**ADDENDUM NO. 2**

**KENDALLVILLE PUBLIC LIBRARY RENOVATION  
MAIN AND LIMBERLOST BRANCHES  
MSKTD Project No.: 8045  
May 9, 2025**

**KPL - First Floor Electrical Power Plan Unit "B"**  
1/8" = 1'-0"

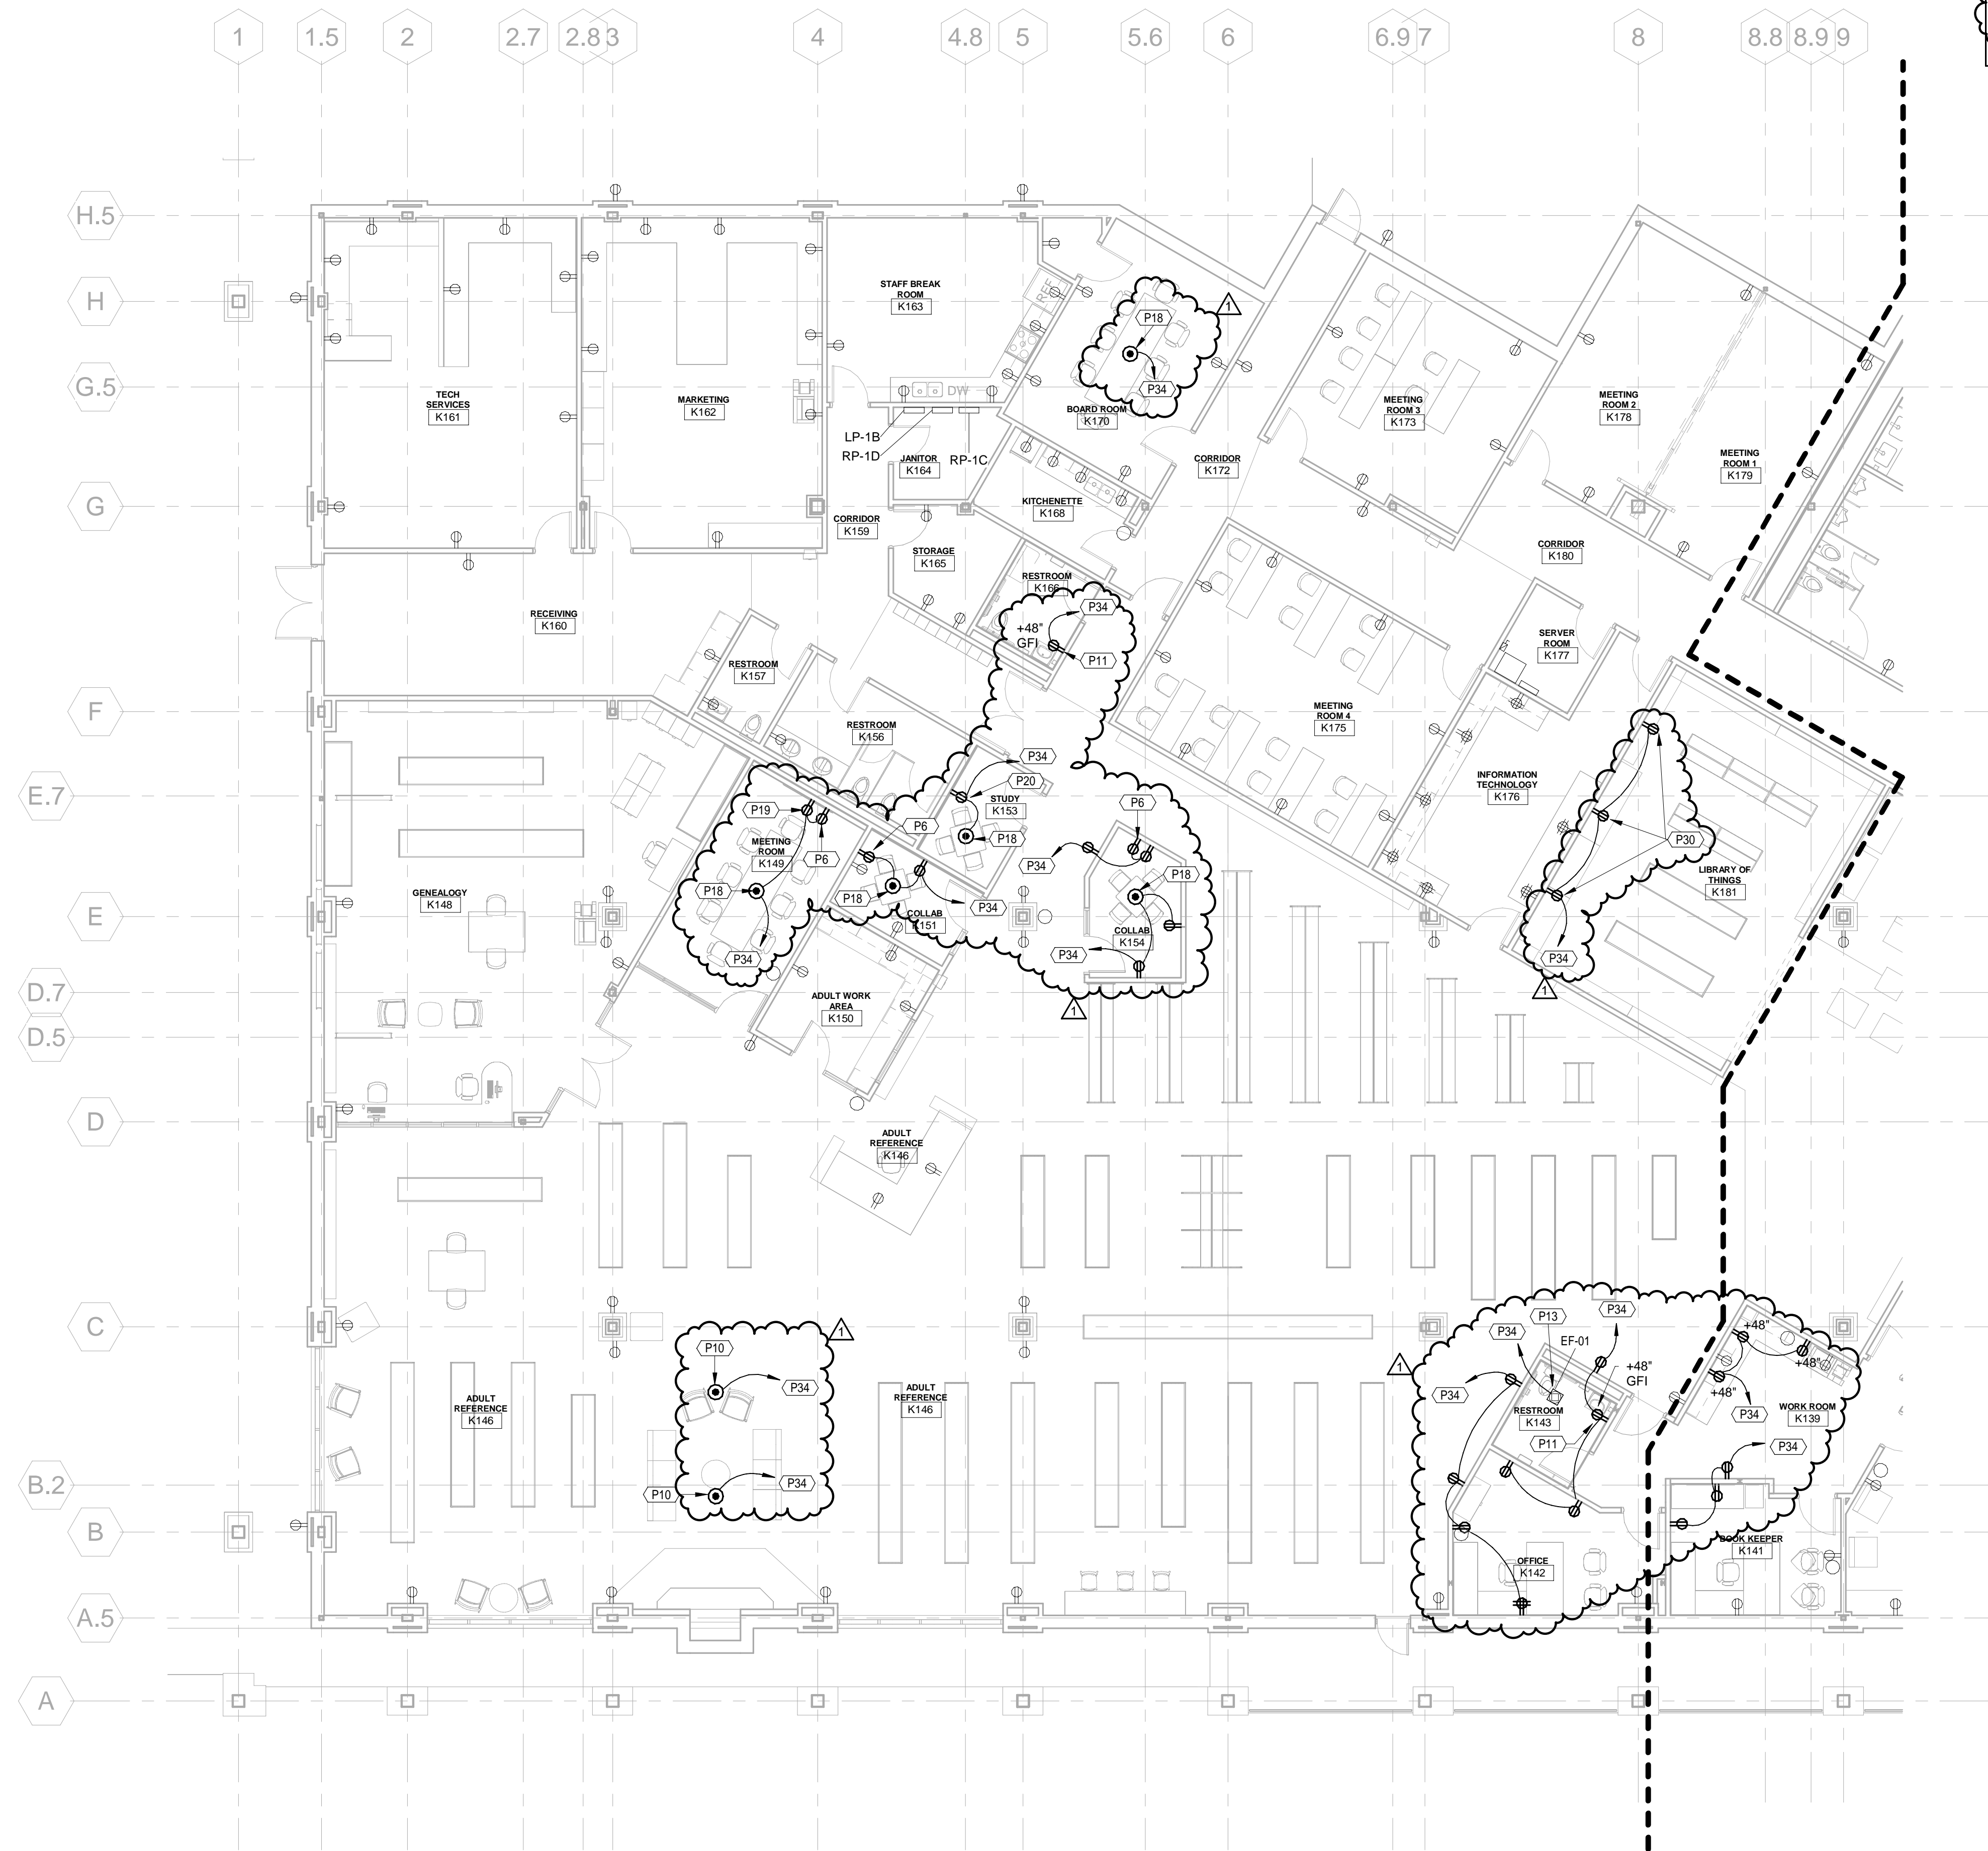
2.9	Drawings Sheet EK201b	<p>Refer to attached, revised sheet EK201b for the following clarifications/revisions:</p> <ol style="list-style-type: none"> <li>1. In Board Room K170, add floor box power circuit and data.</li> <li>2. Revise Power plan note P10.</li> <li>3. In Library of Things K181, show circuit and add Power plan notes P30 and P34 on receptacles.</li> <li>4. In Office K142, Restroom K143, Workroom K139, Bookkeeper K141 and Adult Stacks, show circuits and add Power plan notes P34 on receptacles. Add Power plan note P13 for EF-01.</li> <li>5. In Meeting Room K149, Collab K151, Study K153, Collab K154 and Restroom K166, show circuits and add Power plan notes P34 on receptacles.</li> </ol>

**KPL - First Floor Electrical Lighting Plan Unit "A"**

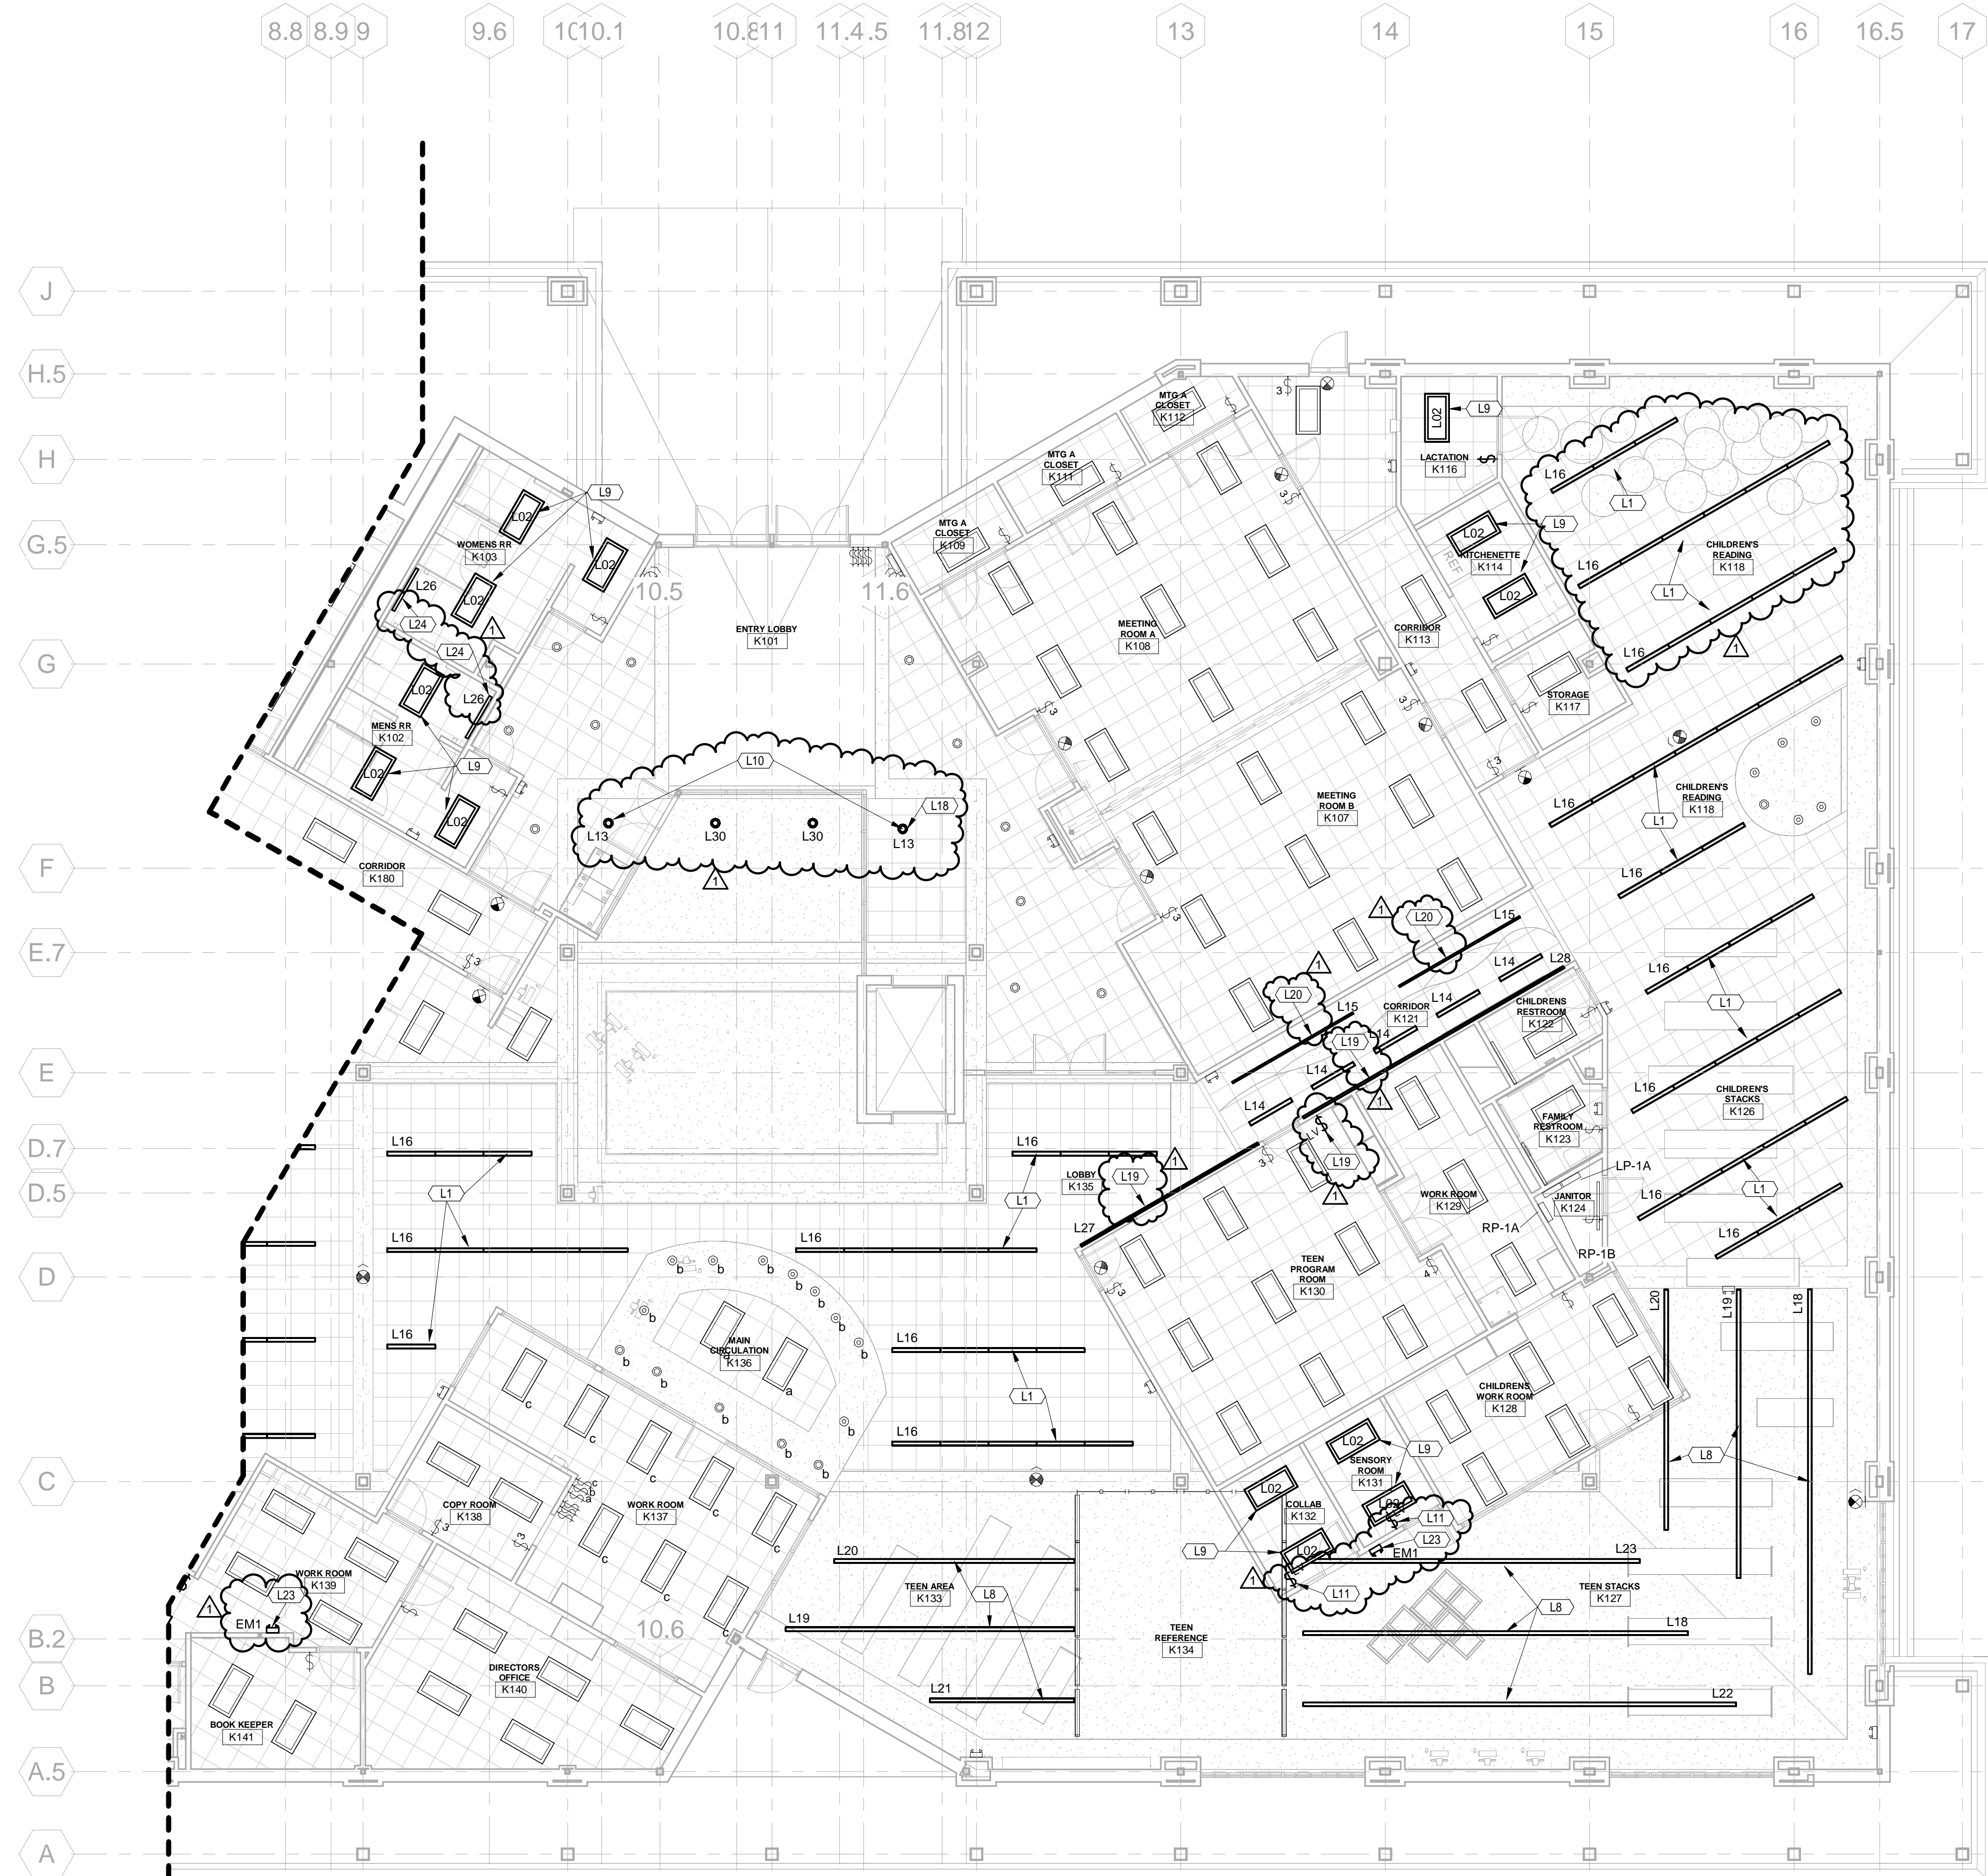
2.10	Drawings Sheet EK301a	<p>Refer to attached, revised sheet EK301a for the following clarifications/revisions:</p> <ol style="list-style-type: none"> <li>1. In Entry Lobby K101, add (1) L13 light fixture and show (2) L13 lights changed to L30 lights.</li> <li>2. In Women's RR and Men's RR, added lighting plan note L24.</li> <li>3. Added plan notes L19 &amp; L20 to sheet and in corridor K121 and K130.</li> <li>4. Added Plan notes L11 and L24 to sheet.</li> <li>5. In Children's Reading K118, revised to show the L16 lights are continuous rows of individual fixtures.</li> <li>6. In Collab K132 and sensory room K131, add plan notes L11.</li> <li>7. In Teen Stacks outside Sensory room K131 add Lighting plan note L23 and fixture tag for EM1.</li> <li>8. In Workroom K139 add EM1 light and Lighting plan note L23.</li> </ol>
